RIVERWOOD SUBDIVISION, PHASE ONE A

APPLICATION NUMBER 9 DATE February 16, 2006
APPLICANT Riverwood Estates Subdivision, Phase One A
REQUEST Subdivision

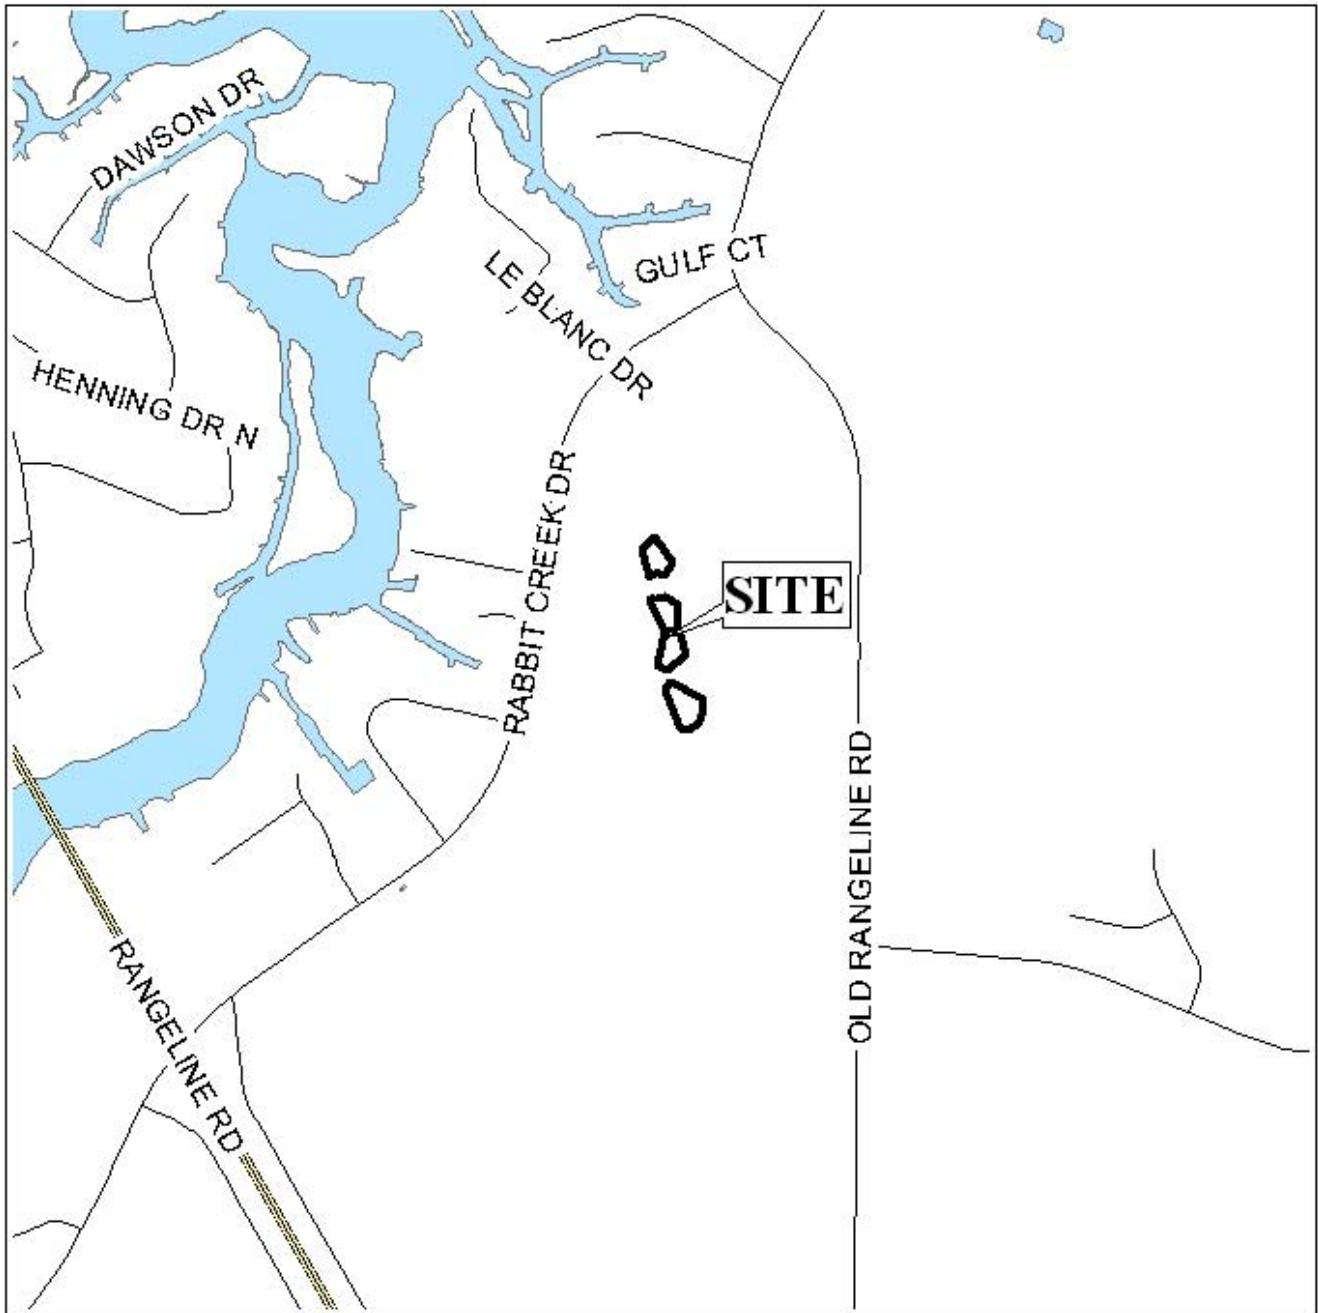
The plat illustrates the proposed 1.3 acre \pm , 4 lot subdivision which is located on the North and South sides of Riverwood Court and Riverwood landing, at their East termini. The subdivision is served by both public water and sanitary sewer.

The purpose of this application is to resubdivide 4 lots that are part of the Riverwood Subdivision, Phase One.

Riverwood Subdivision, Phase One, was approved by the Planning Commission at the April 7, 2005 meeting, with the following condition specifically for the area of the plat currently under review: "submission of documentation to illustrate that lots 48-51 and lots 56-59 provide a minimum area of 7,200 sq.ft. exclusive of wetlands." The Planning Commission has generally taken a conservative approach to the development of properties containing wetlands, and frequently required that the minimum lot area (7,200 sq.ft.) be exclusive of wetlands.

This application appears to specifically address the wetlands concerns stated by the Planning Commission, by reconfiguring lots 48, 51, 56, and 58, and eliminating lots 49, 50, and 57. The reconfigured lots will meet all minimum size and setback requirements, exclusive of wetlands. The eliminated lots 49, 50, and 57 will become part of the wetlands common area / vacant land. The wetlands common area should be appropriately labeled on the Final Plat, if approved, and a note should be placed on the plat stating that all common areas and easements are to be maintained by the property owners association for the development. It should be noted that conveyance of the wetlands common area as a Conservation Easement to a conservation land trust may be appropriate.

The lots in question are not located within the 100 or 500-year floodplains for Dog River or Rabbit Creek, however, the lots as well as the entire Riverwood Subdivision (all phases) appear to be located within an area subject to hurricane-related storm surges.

The site is located in the County, thus a note stating that any lots which are developed commercially and adjoin residentially developed property must provide a buffer, in compliance with Section V.A.7. of the Subdivision Regulations, should be retained for the Final Plat, if approved.

The plat is recommended for Tentative Approval subject to the following conditions: 1) placement of a note on the Final Plat stating that easements and common areas are to be maintained by the property owners association; 2) labeling of wetland areas as common areas, if applicable; 3) placement of a note on the Final Plat stating that any lots which are developed commercially and adjoin residentially developed property shall provide a buffer in compliance with Section V.A.7. of the Subdivision Regulations, and; 4) approval of all applicable federal,

state and local agencies regarding the wetlands and floodplain issues prior to the issuance of any permits.
